February 29, 2016

Re: Updated NGRP Site Maps for Pilgrim Nuclear Power Station

On behalf of Jones River Watershed Association (JRWA), I would like to provide you with updated site maps for Entergy's Pilgrim Nuclear Power Station that were commissioned from Northeastern Geospatial Research Professionals (NGRP).

Pilgrim Nuclear Power Station | Shoreline Profile Sections

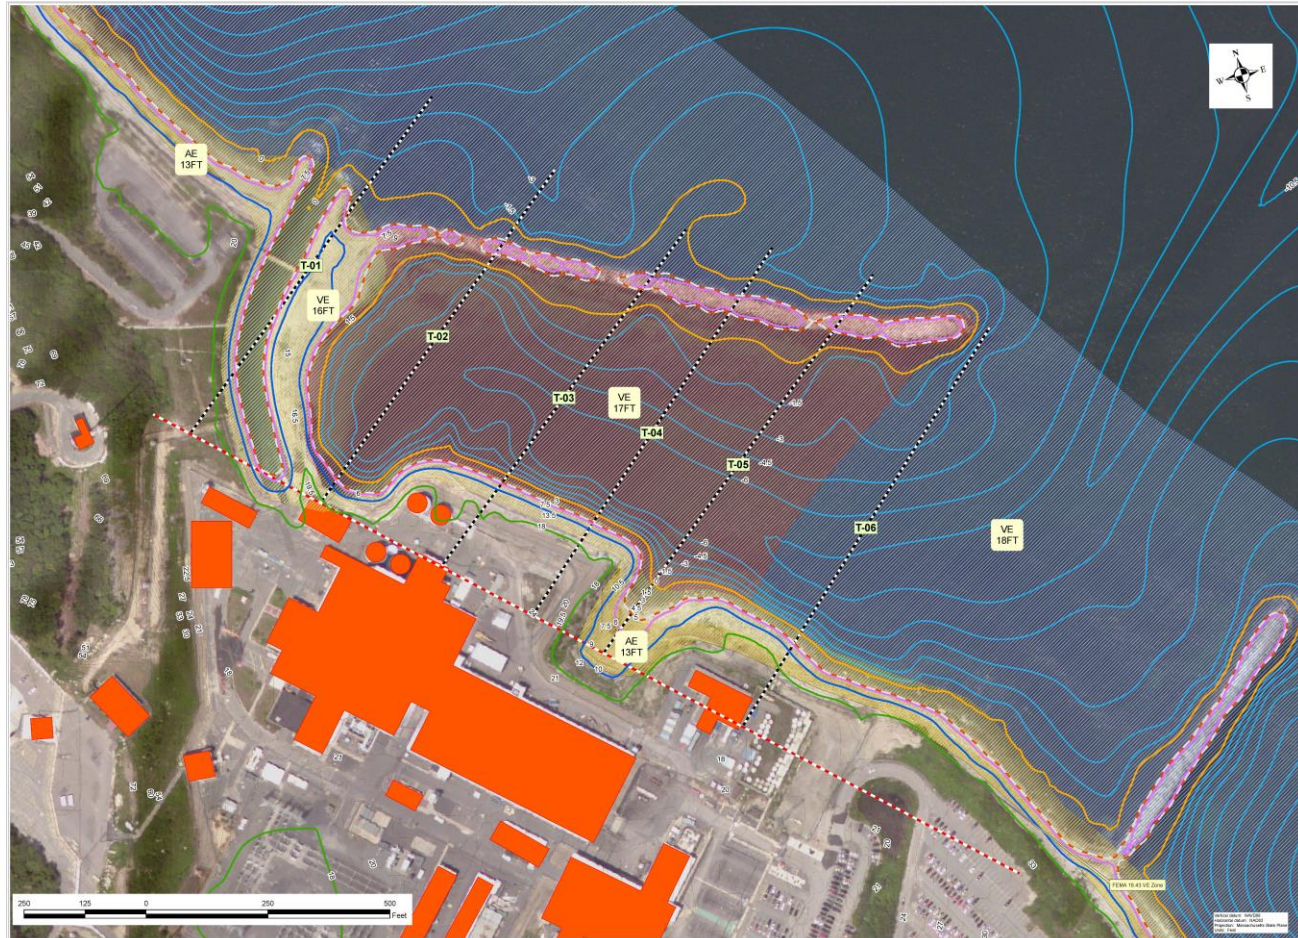
- Entergy's site maps prior to 2014 used outdated data from 1968 (mean sea level today is more than 6 inches higher than it was in 1968) to develop site plans for infrastructure (including its dry cask storage facility); those plans do not reflect current NAVD88 topographical elevations and do not provide an accurate basis for evaluating risks of sea level rise and other coastal impacts.
- The height of the breakwater jetties and other elevations in NGRP's maps appear significantly lower than those shown in Entergy's plans, and are uneven, demonstrating that the site is not as protected from flooding and sea level rise as Entergy reports.
- There are discrepancies ranging from +4 in. to -15 ft. when comparing Entergy's plans to more current elevation information because Entergy uses mixed and outdated standards of measurements for vertical elevations and water levels.

Pilgrim Nuclear Power Station | FEMA Flood and LIDAR Elevations

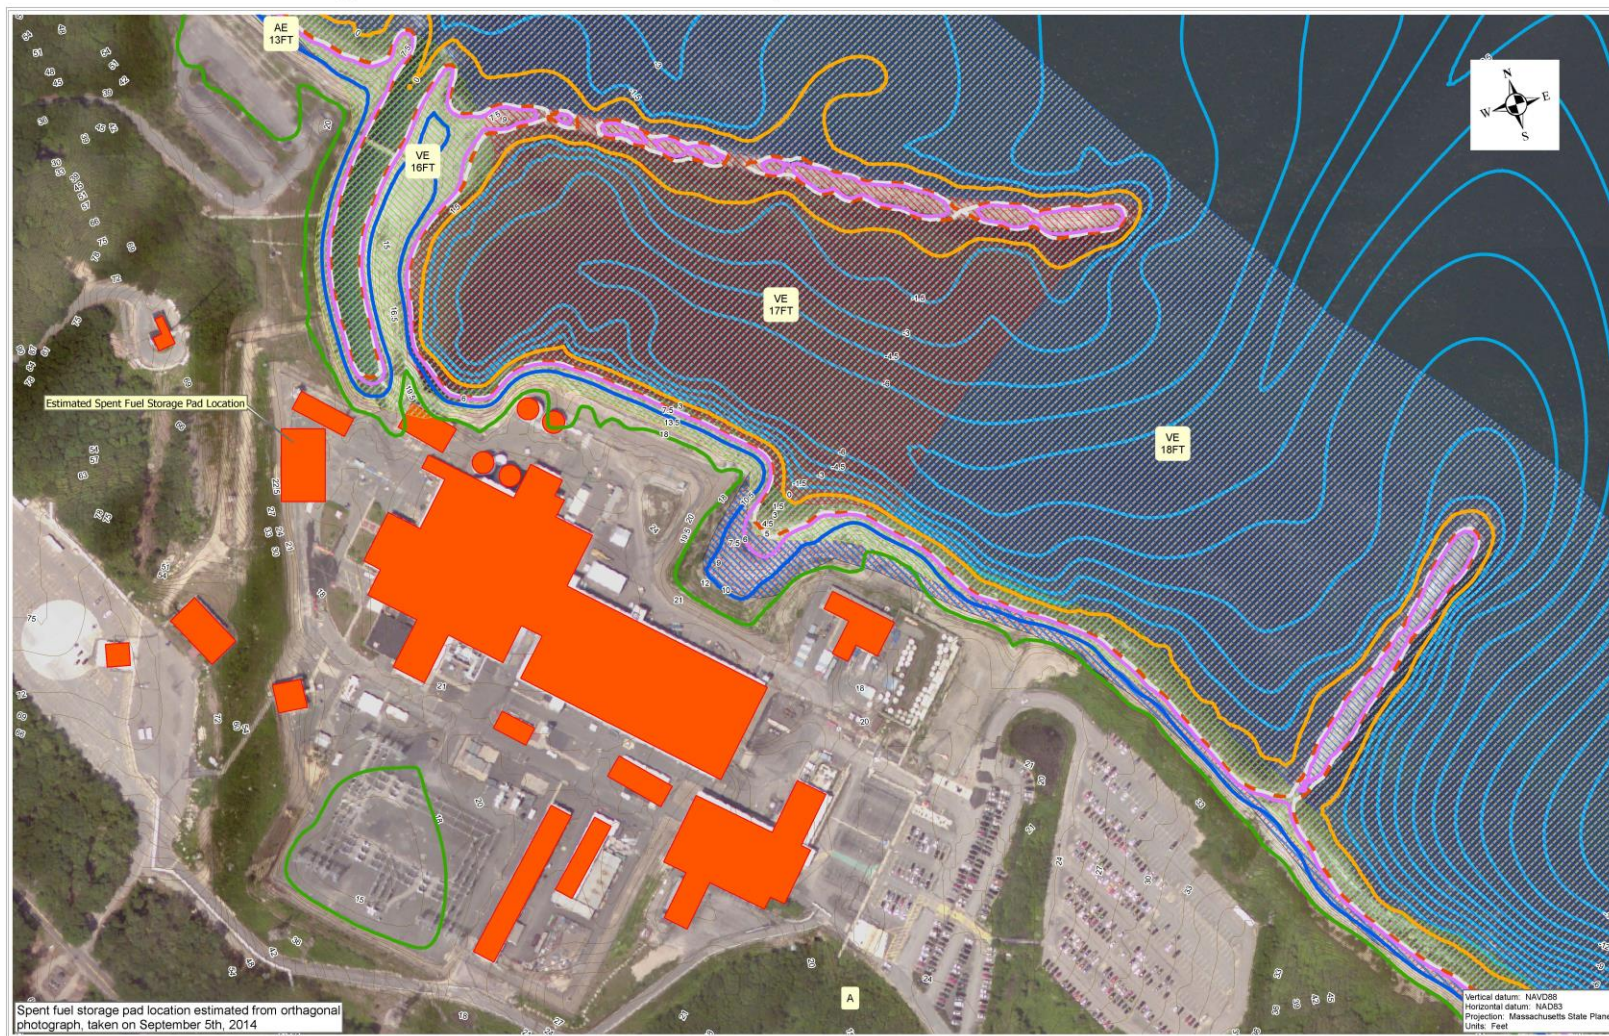
Entergy claims that it performed a site survey and its own aerial LiDAR mapping for the Pilgrim site (2014), but has not made these products publically available. It would be most useful to be able to compare Entergy's 2014 site survey and LiDAR maps that are referred to in the AREVA Report to the products produced by NGRP.

Pilgrim Nuclear Power Station | Historical Site Plan and Elevations

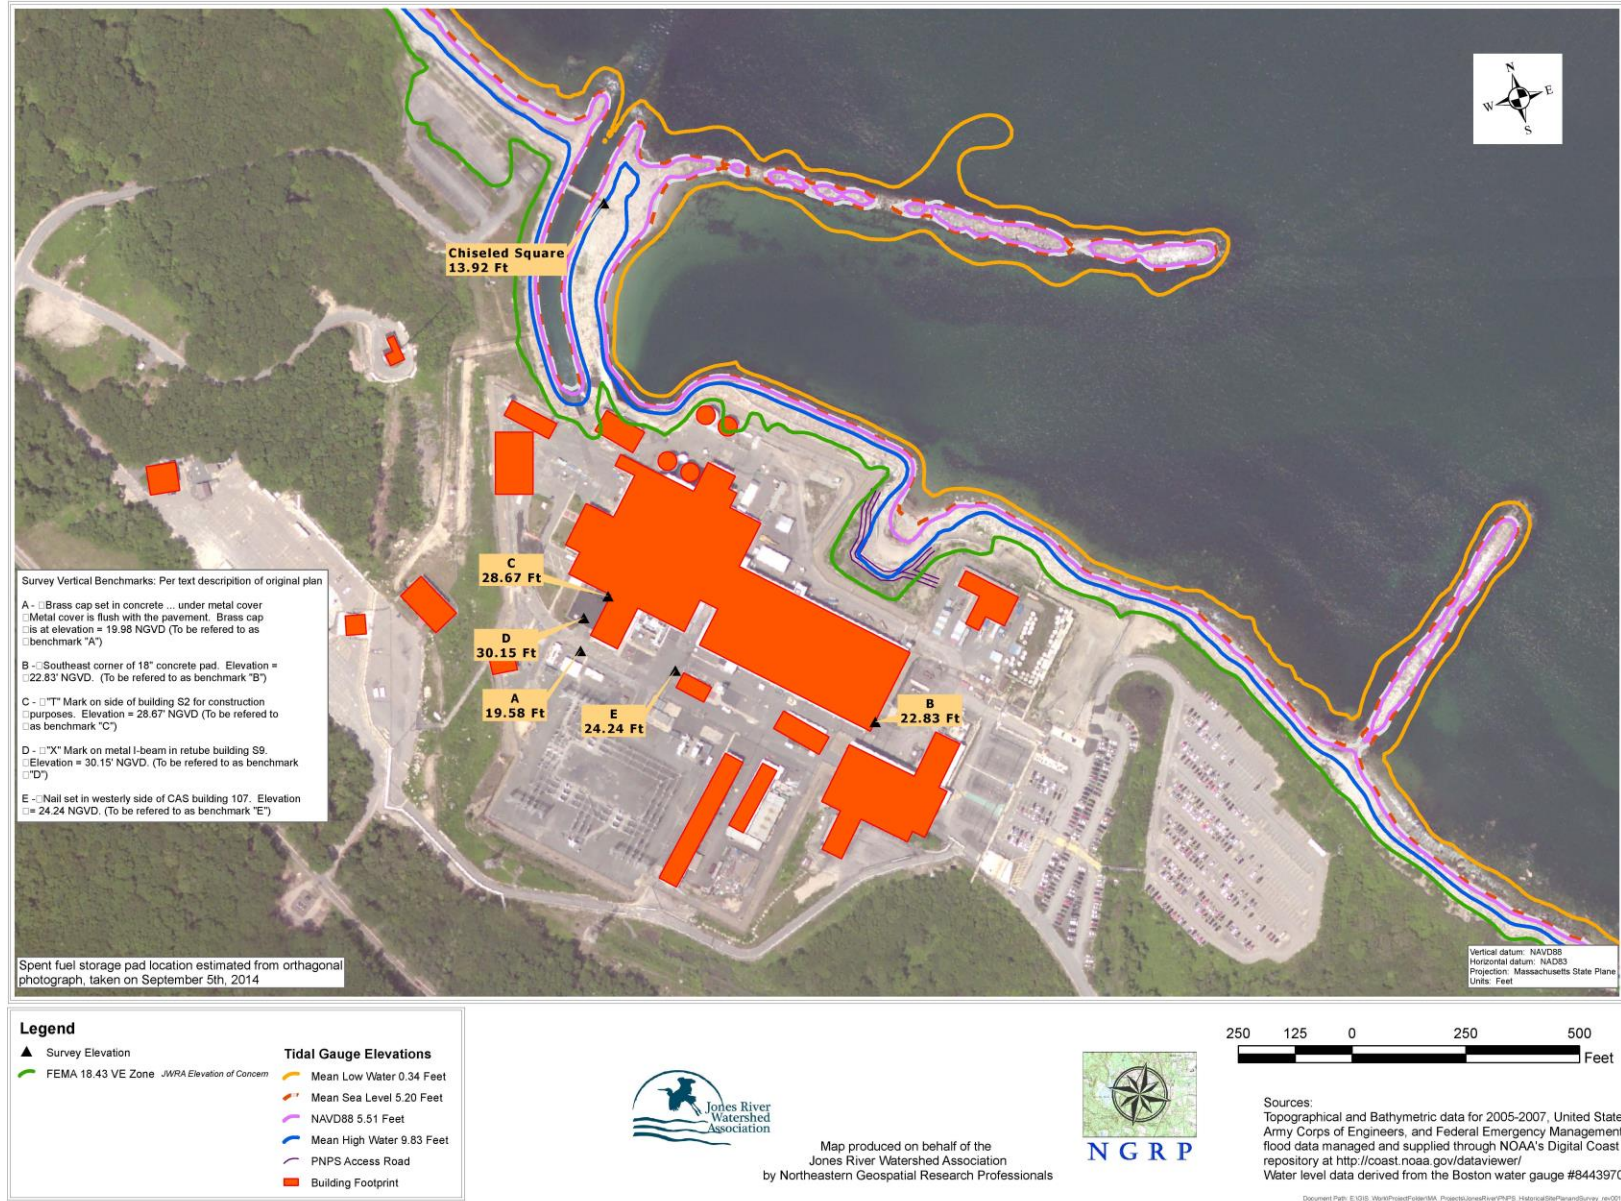
Entergy's previous site plans falsely claim the site is more protected than it actually is. Since Pilgrim will be ending operations soon, it is critically important to fully understand the risks associated with coastal hazards in order to implement a timely clean up and decommissioning strategy. As sea levels increase, so do groundwater elevations that will affect contamination present on the site. These new NGRP maps illustrate the need for Pilgrim to be decontaminated and decommissioned within a decade of closure, as opposed to being allowed to sit idle for decades or up to 60 years under long-term SAFSTOR.

Pilgrim's dry cask storage facility and stranded "low-level" radiological waste storage areas are also adjacent to the shoreline, and vulnerable to coastal inundation. Climate change will bring a radical increase in regional sea levels and coastal storms. Increasingly, predictions dictate that all nuclear waste should be shipped offsite within a decade of closure. These corrected NGRP maps illustrate certain urgency for nuclear waste storage areas to be moved farther away from Cape Cod Bay and to higher elevations, or moved offsite, in order to protect people and the environment. This will help avoid potential accidents and leaks and will set the stage for complete and thorough site cleanup. This issue should be addressed immediately, before more casks are filled after shutdown.
